ROOF DECK DESIGN MANUAL FIRST EDITION

Errata #2 11 November 2014

Figure 1.3 - Wide Rib (WR) Deck

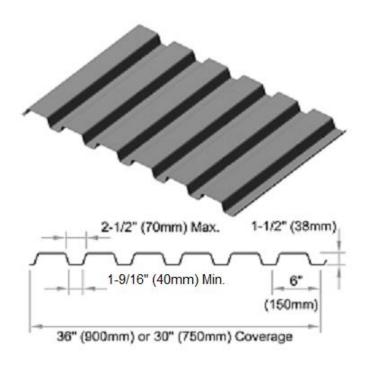
In Figure 1.3, change the bottom flange width as shown.
